Date: 6/25/2019
To: North Dakota Public Service Commission
Copy to: Mike Stahly, Cenex Pipeline, LLC
From: Grady Wolf - KLJ
Cenex Pipeline, LLC. Liquid Petroleum Pipeline
RE: Addendum to Certificate of Corridor Compatibility and Route Permit
Case No. PU-17-97

**Cenex Pipeline, LLC
Refined Fuels Pipeline**

**Route Changes
Within Corridor**

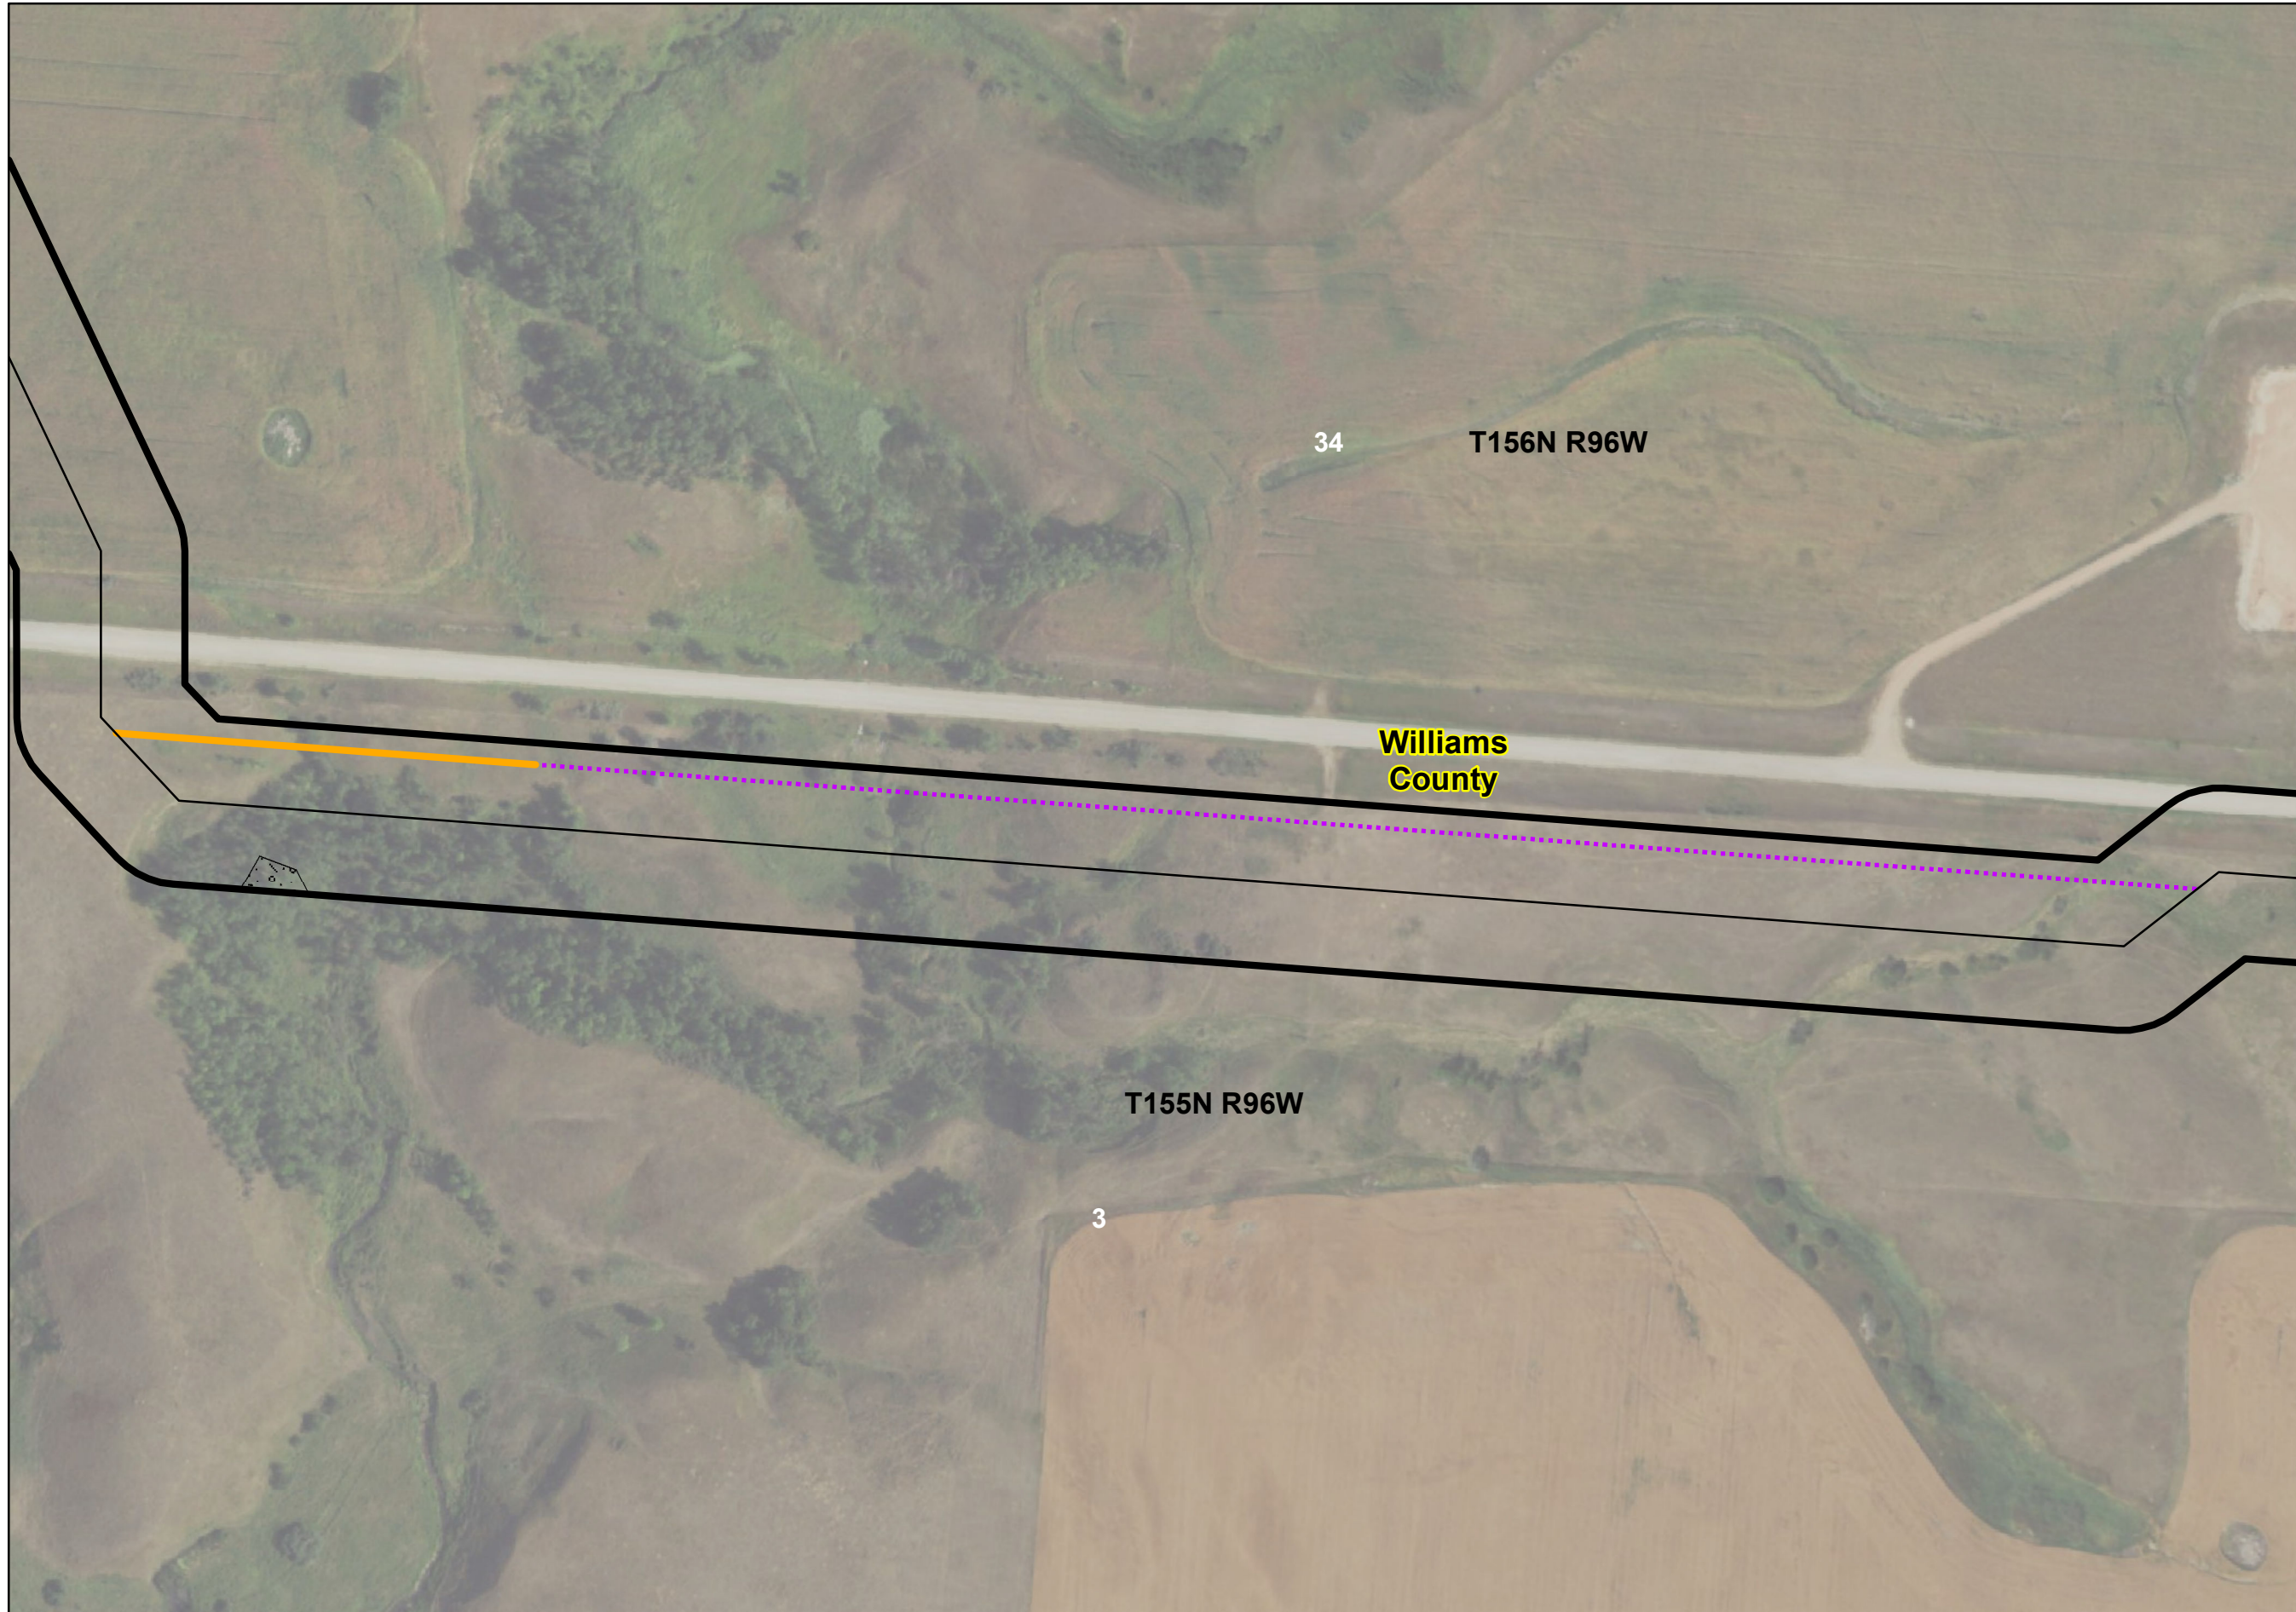
During a recent field visit with the construction contractor to the GUA in Section 3, Township 155N, Range 55W, in Williams County, North Dakota, it was determined that a shift in the route alignment and alternative construction method will simplify construction from the previous route and construction method presented to the PSC (see, Docket No. 90). The proposed route would be shifted north approximately 75 feet and would continue to run parallel to the road within the 200-foot permitted corridor. Due to steep topography at the eastern portion of the reroute, HDD will be utilized to further avoid disturbance of the GUA. The HDD method was determined to be an acceptable method for avoidance of GUA's as outlined in Exhibit No 25. This memo takes into account the proposed reroute which occurs entirely within the previously approved 200-foot corridor.

With the exception of the change in construction method chosen for work within the GUA, analysis of the reroute did not identify any significant changes when compared to the analysis discussion included in the February 2017 Consolidated Application for a Certificate of Corridor Compatibility and Route Permit applications. No additional exclusion or avoidance areas were identified along the proposed reroute, and therefore the route adjustment is not anticipated to result in any additional impacts than those previously filed with the PSC.

Re-Route Length: 2480 FT

Closest Distance to Corridor: 25 FT
